SUBJECT: **Summary and Review of Investigations at KAFB-Battery Shop
French Drain**

The Technical Section, as requested by Stephanie Stoddard of the RCRA Permitting Program, was asked to do a technical review of the documents listed below concerning a demonstration of clean closure of the French Drain (FD) unit at Kirtland Air Force Base (KAFB).

H+GCL, as consultant to KAFB on the Battery Shop French Drain site, has prepared a (draft) Closure Plan (May 12, 1989); a Soil-Vapor Survey report (May 22, 1992); and a Results of Subsurface Investigation report (September 30, 1992).

FIGURE 2

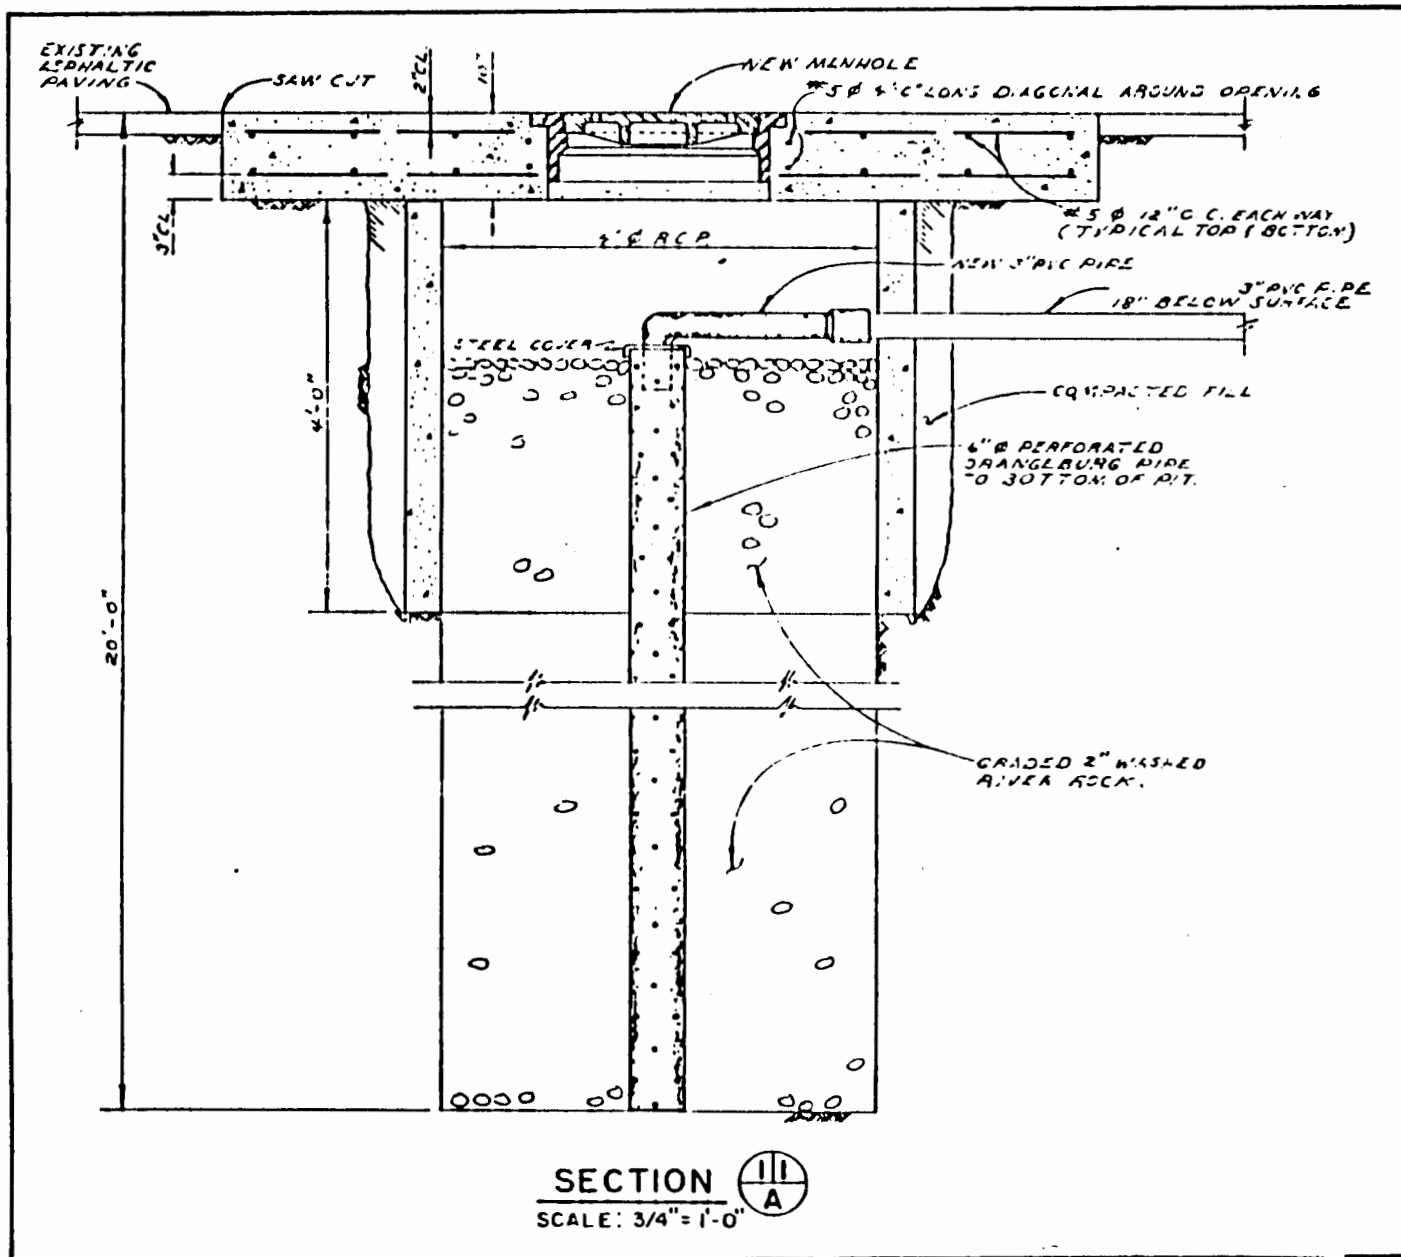
1. No material (LS chips, gravel, or soil) was apparently removed from the FD prior to being filled with concrete and capped. The Draft Closure Plan, which became the Closure Plan (per Stephanie Stoddard) did not really stipulate necessity for removal of material.

FIGURE 4

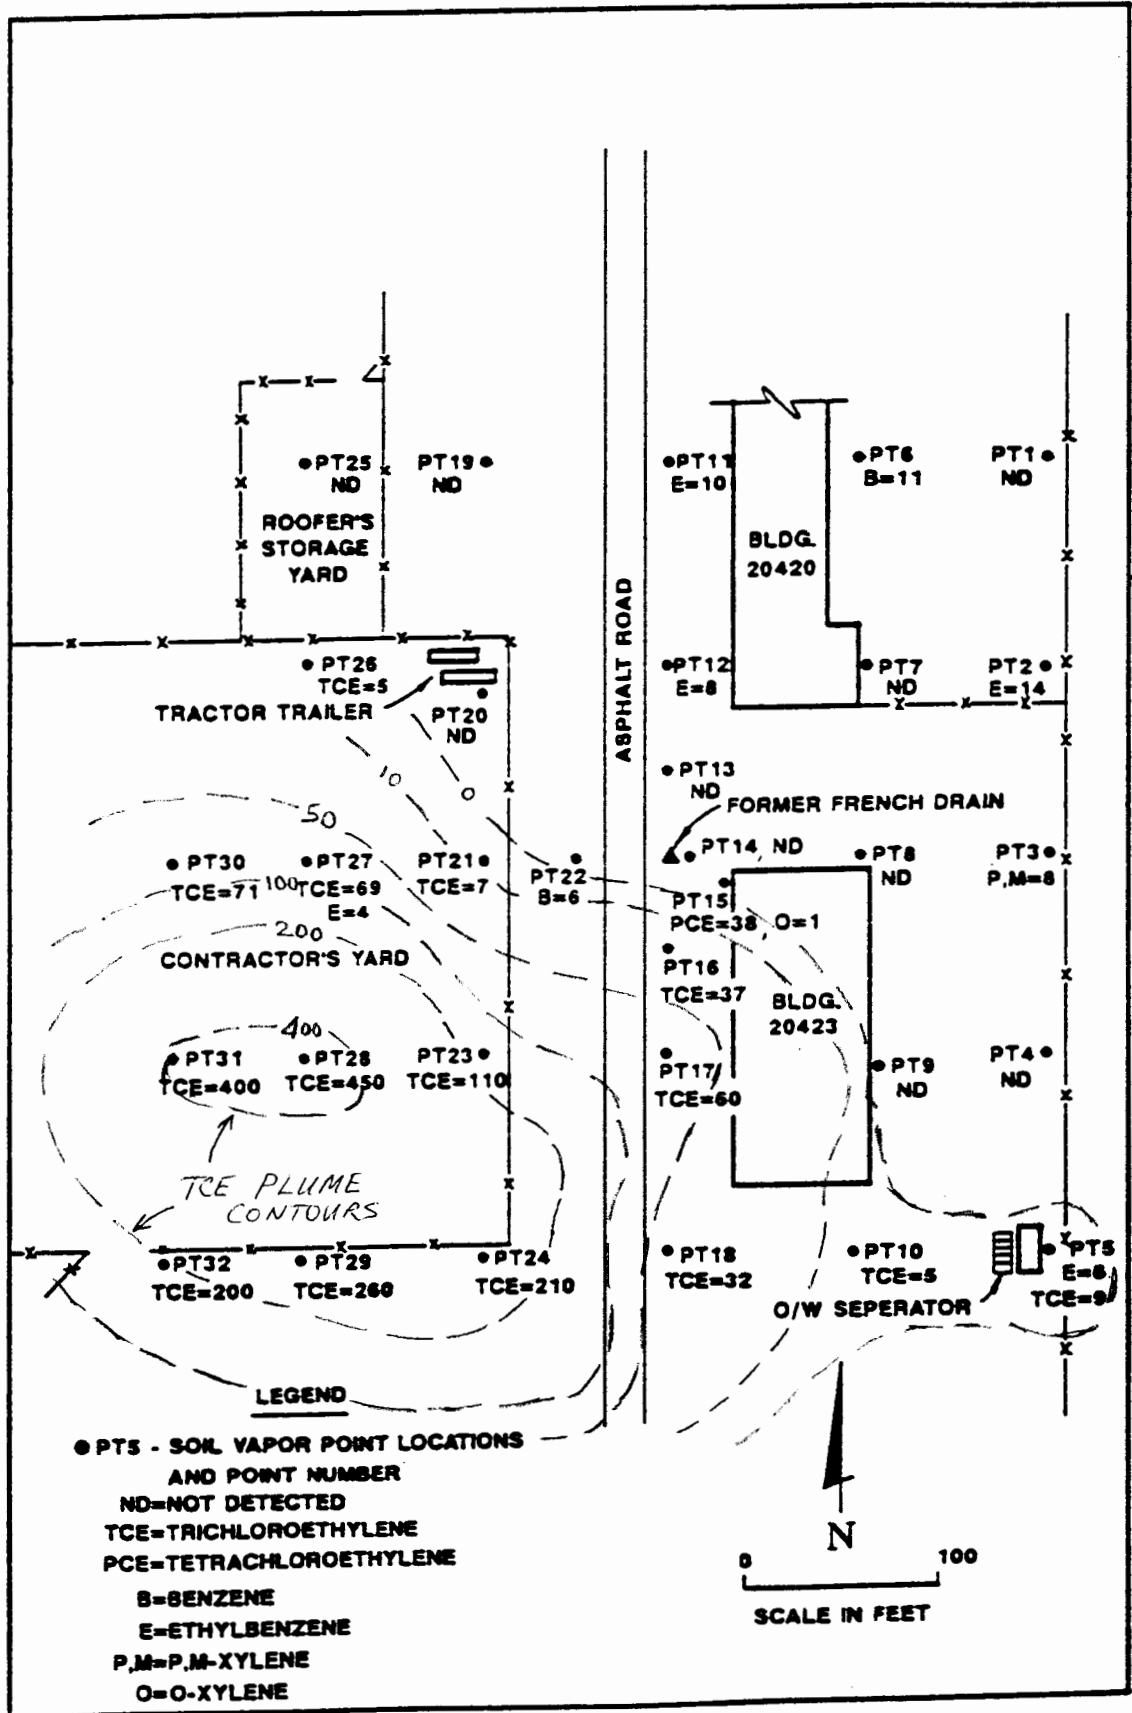
2. During H+GCL's soil-vapor survey, there was an apparent "halo" of ethylbenzene (5 of 32 samples) within 100' to 300' of the FD. The last program of soil boring and analysis may not have tested for this possible contamination.

3. During H+GCL's soil-vapor survey, PCE and O-Xylene were detected near the former pipes (removed) leading from Bldg. 20423 to the FD. Subsequent borehole drilling and analysis may not have addressed this possible contamination.

FIGURE 5

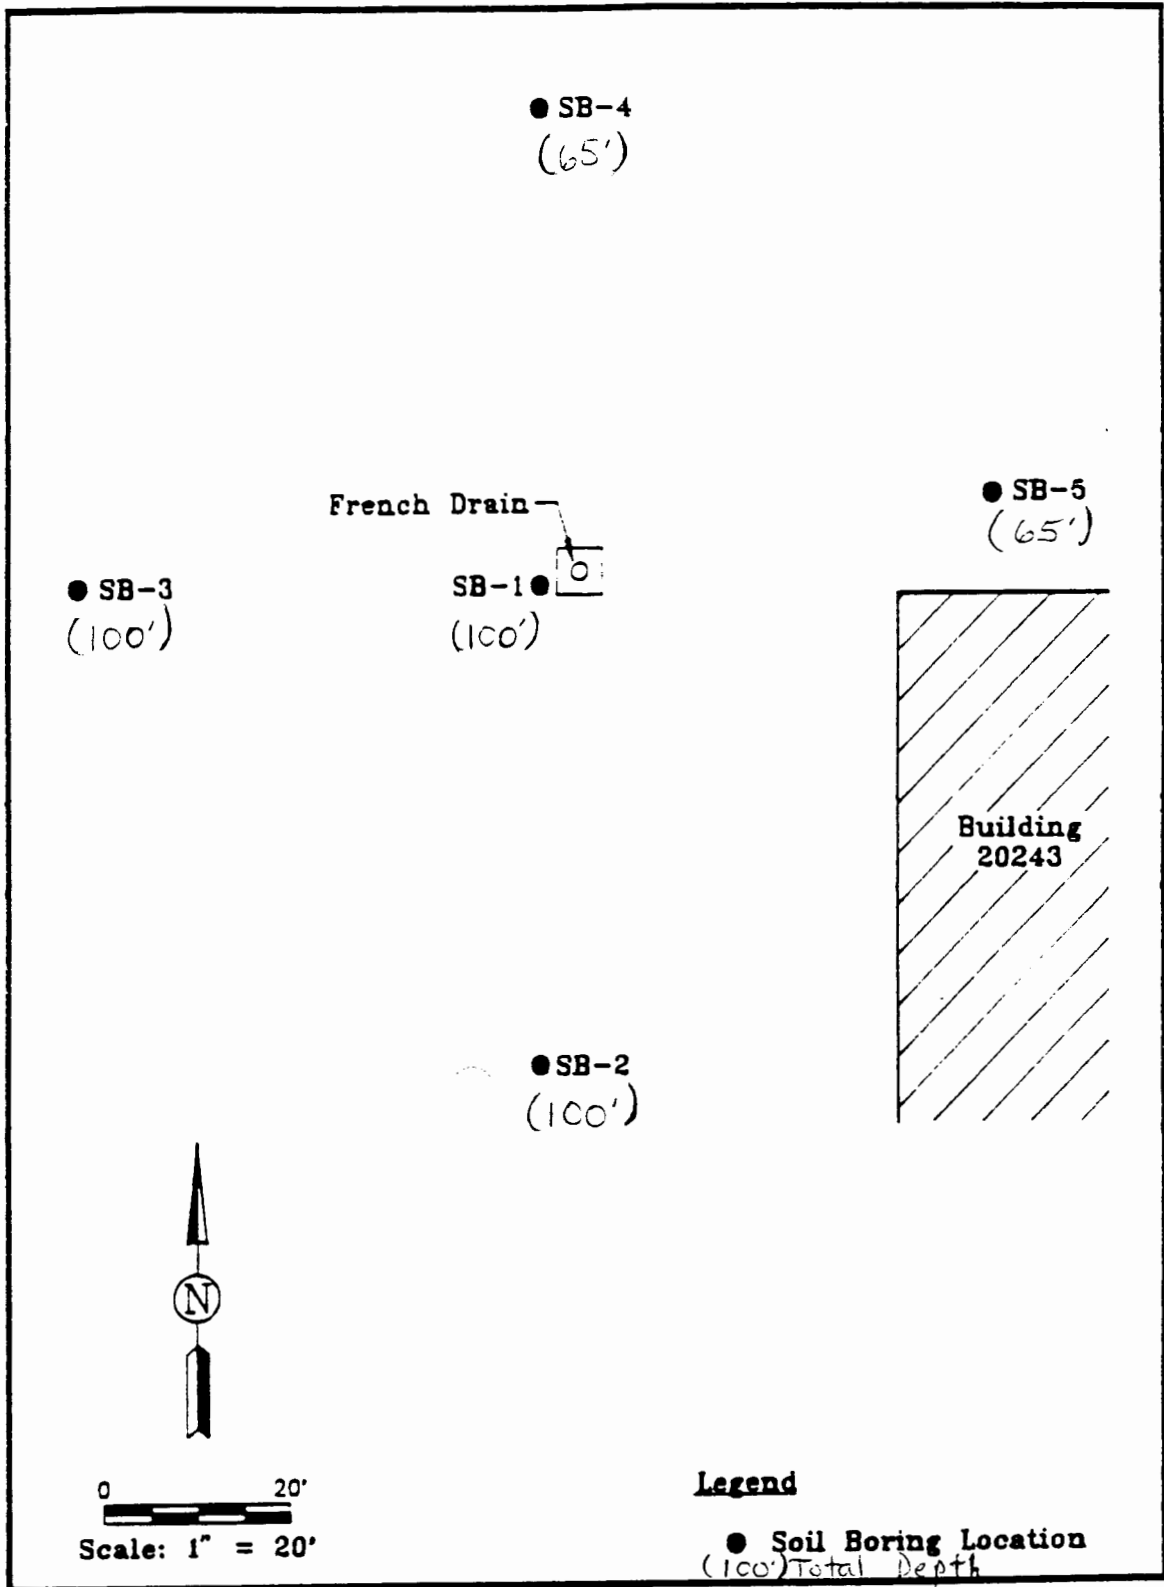
4. Detectable MeCl occurred in two samples from hole SB-4 in the last drilling program. H+GCL assumed laboratory contamination, but there was no support for this contention (**analytical reports for those samples are not included in NMED's copy of H+GCL's last report**).
